Rockland Ltd

Mr. Audie MacDonnell
Yukon Zinc Corporation
Suite 701, 475 Howe Street
Vancouver, BC
V6C 2B3

January 2, 2011

Re: INSPECTION REPORT FOR QUARTZ MINING LICENSE - UNDERGROUND GEOTECHNICAL
INSPECTION

Figure 1: Ramp, SAs, Stopes and FARs at Wolverine mine

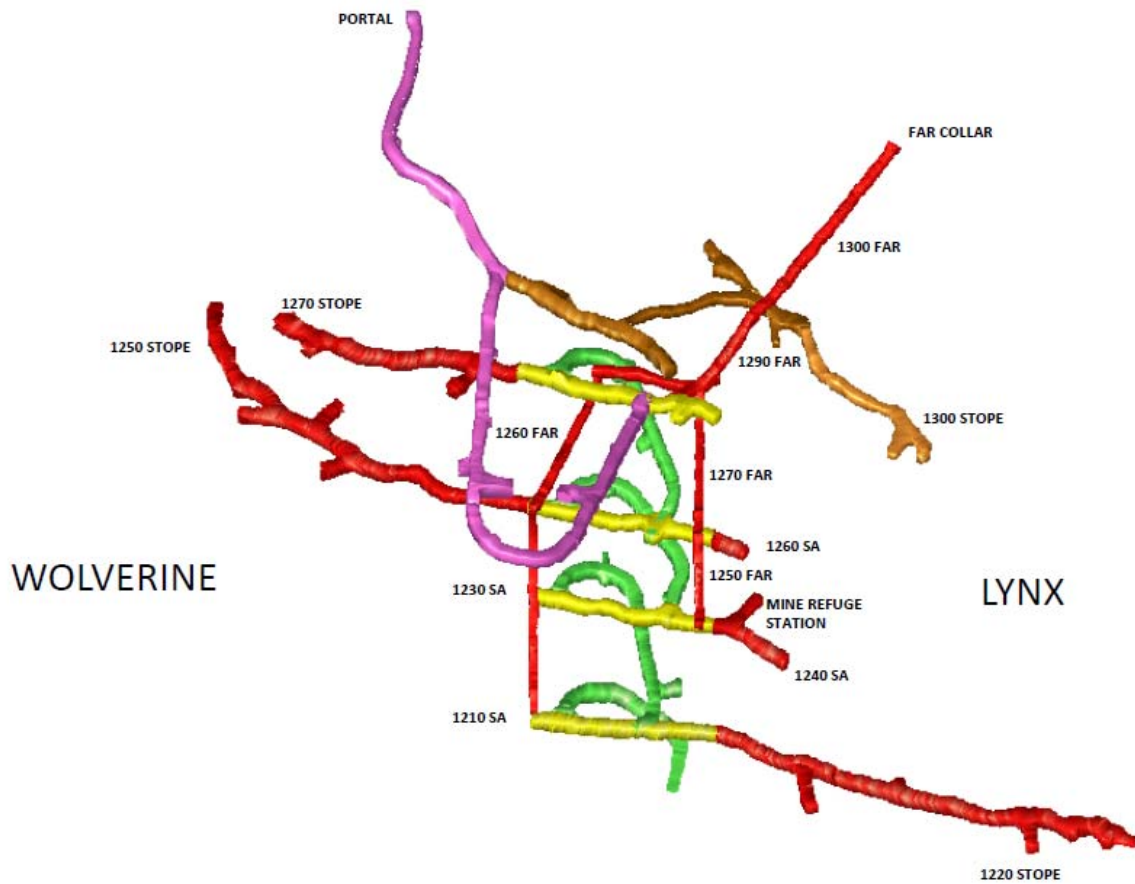
- ❖ The inspection of bullhorn area indicated that several have moved and all bullhorns should be replaced with a better alternative. A bracket and bolting combination which minimizes the movements was recommended;

- ❖ The minimum ground support guideline outside the bullhorn area was established which requires placement of additional 3.7 m (12') Super Swellex and 2.4 m (8') Swellex or equivalent bolts on a 1.2 m x 1.2 m (4' x 4') grid on the back and walls respectively. Since the ground support was installed in 2005, the shotcrete, Fibre Reinforced Shotcrete (FRS) thicknesses and presence of Galvanized Welded Wire Mesh (GWWM) should be checked;

- ❖ All back intersections should be reinforced with 3.7 m (12') Super Swellex placed on a 1.2 m x 1.2 m (4' x 4') grid, GWWM and 12 cm (5") shotcrete thickness; and,

- ❖ A monitoring and quality control program, as described in the inspection report, should be implemented;
- ❖ Though the suggested brackets are significantly better than the installed bullhorns, it could gradually move and regarded as "temporary" type ground support. The recommendation was subsequently amended with a "permanent" type of ground support for this area;

- ❖ For back up to 8 m wide and walls up to 4 m high, the minimum ground support for the bullhorn area should consist of 3.7 m (12') and 2.4 m (8') Super Swellex and Swellex placed on a 1 m x 1 m (3' x 3') grid in the back and walls respectively and 20 cm (8") shotcrete on the back and walls to the sill. However, where the wall height exceeds 4 m, 3 m (10') Swellex should be implemented; and,

- ❖ In the "extremely poor / exceptionally poor ground condition" of the cribbed / steel set area, the Connectable Swellex support should also be employed. For drift up to 3.6 m x 3.6 m, 6 m (20') long connectable Swellex should be placed on a 1.8 m x 1.8 m (6' x 6') grid. The pattern should include one in the crown (center back), one on each shoulder wall and one in the mid height of each wall. As the wall height increases, the connectable length on the wall should increase too.

- ❖ The stability, based on a visual monitoring classification, in general, appeared to be “fair to good” with no evidence of any structural or stress controlled sloughing. Several maintenance recommendations, as identified in this report, should be implemented;

- ❖ The results of numerical modelling and empirical assessments indicated that Crossover 2 is “unstable” and Crossovers 1, 3 and 9 are “stable”;
- ❖ Using the numerical modelling, additional ground support systems were recommended for crossovers;

- ❖ In order to monitor Crossovers 2 and 3, an instrumentation program consisting of several extensometers should be implemented;
- ❖ The ground support guideline requires placement of additional Super Swellex and Swellex or an equivalent bolts and shotcrete; and,

- ❖ The intersection ground support requirements were evaluated and additional ground support, as specified in the inspection report, should be implemented.

- ❖ Excluding the bottom of the ramp, no fall of ground or instability has been reported and the stability, in general, appeared to be “fair to good”. In the bottom of the

- ramp, shotcrete cracking and fall out of the back are evident due to bigger ramp dimensions, presence of ramp crossovers and higher depth;
- ❖ Up to 160 m below the surface, the minimum ground support, consisting of 3.7 m (12') and 2.4 m (8') Super Swellex and Swellex placed on a 1.2 m x 1.2 m (4' x 4') grid in the back and walls respectively and 10 cm (4") shotcrete to 1.5 m (5') from the sill are required. From 160 m below the surface to the end of the ramp at 200 m below the surface, the walls ground support should increase to 3 m (10') long. This minimum ground support guideline should also include #8 GWWM on the back and walls to 1.5 m (5') from the sill and 50 mm (2") FRS for the remainder of walls;

- ❖ The results of numerical modelling and empirical assessments indicated that Crossovers 4, 5 and 7 are "unstable" and Crossovers 6 and 8 are "stable";

- ❖ Using the crossover dimensions and numerical modelling, the ground support for each crossover were recommended;
 - ❖ The ramp intersection ground support requirements were evaluated and additional ground support should be implemented as recommended in the inspection report;

- ❖ In order to monitor Crossovers 4, 5 and 7, an instrumentation program consisting of several extensometers should be implemented; and,
 - ❖ Minimal sill survey shots available at / from crossover 7 to the end of the ramp. The actual ramp dimensions should be compared to ramp dimensions considered in this report and the ground support should be adjusted where significant deviation is observed.

- ❖ Excluding the accident location in 1220 SA, the stability appeared to be “fair to good” in SAs and Stopes. No falls of ground or instability has been reported in FARs and, excluding 1290 Draise, the stability appeared to be “fair to good”;

- ❖ A review of major structures within SAs indicates presence of numerous faults and shear zones some containing significant gouge and graphitic shear zones. The average rock quality of SAs and Stopes is “very poor” based on the Q rock mass classification;

- ❖ Representative in-situ stress field are essential to confirm various analyses carried out, for future geomechanical analyses and mine planning purposes. An in-situ stress measurement program should be planned as soon as possible;

- ❖ The minimum ground support for 1300 SA, 1250 SA and 1270 SA, should consist of 3.7 m (12’) and 2.4 m (8’) Super Swellex and Swellex placed on a 1.2 m x 1.2 m (4’ x 4’) grid in the back and walls respectively and 5 cm (2”) shotcrete to 1.5 m (5’) from the sill. However, where the wall height exceeds 5 m (16’), 3 m (10’) Swellex should be implemented. For 1220 SA, where the typical SA dimension is 5.5 m high x 5.2 m wide, the walls’ ground support should be 3 m (10’) long at all time and 7.5 cm (3”) shotcrete. This guideline should also include #8 GWWM on the back and walls to 1.5 m (5’) from the sill and 5 cm (2”) and 7.5 cm (3”) FRS for the remainder of walls;

- ❖ The Stopes’ ground support should be 3.7 m (12’) and 2.4 m (8’) Super Swellex and Swellex placed on a 1 m x 1 m (3’ x 3’) grid in the back and walls respectively to 1 m from the floor with the mid-height wall support of 12’ (3.7 m) long. For 1220 Stope, where the typical SA dimension is 5.5 m high x 5.2 m wide, the walls’ ground support should increase to two 3.7 m (12’) long Swellex at the mid-height on walls. This guideline should also include #6 GWWM on the back and walls to the sill;

- ❖ The actual size, including the cobbling height, and shape of excavations have significant influence on the size of yielded element zone around the SAs / Stopes and required ground support. In order to maintain stability, future dimensions (with cobbling height) of SAs / Stopes and including extension of current Stopes, as stated in the Wolverine feasibility study (Snowden, 2007), should be limited to 4 m (H) x 4

- m (W). Where Stope dimensions exceed these dimensions, depending upon the excavation size, longer bolts with shotcrete should be implemented for SAs and Stopes;

- ❖ The minimum ground support for intersections within SAs should consist of 3.7 m (12') and 3 m (10') Super Swellex and Swellex placed on a 1.2 m x 1.2 m (4' x 4') grid in the back and walls respectively and 7.5 cm (3") shotcrete to 1.5 m (5') from the sill. This guideline should also include #8 GWWM on the back and walls to 1.5 m (5') from the sill and 7.5 cm (3") FRS for the remainder of walls;

- ❖ The minimum ground support for FARs should consist of 2.4 m (8') Swellex placed on a 1.2 m x 1.2 m (4' x 4') grid in the back and walls respectively and 7.5 cm (3") shotcrete to 1 or 1.5 m (3' or 5'), depending upon the FAR size, from the sill. This minimum ground support guideline should also include #8 GWWM on the back and walls to 1 or 1.5 m (3' to 5') from the sill, depending upon the FAR size, and 7.5 cm (3") FRS for the remainder of walls; and,

- ❖ The minimum ground support of overcasts' walls or back up to 5 m should consist of 3.7 m (12') Swellex placed on a 1.2 m x 1.2 m (4' x 4') grid with #8 GWWM and 13 cm (5") shotcrete on the back and walls to 1.5 m (5') from the sill and 13 cm (5") FRS for the remainder of walls. For the walls or back greater than 5 m and less than 10 m, the minimum ground support should be replaced with 5.5 m (18') Swellex with the same pattern and GWWM but 15 cm (6") shotcrete and 15 cm (6") FRS.
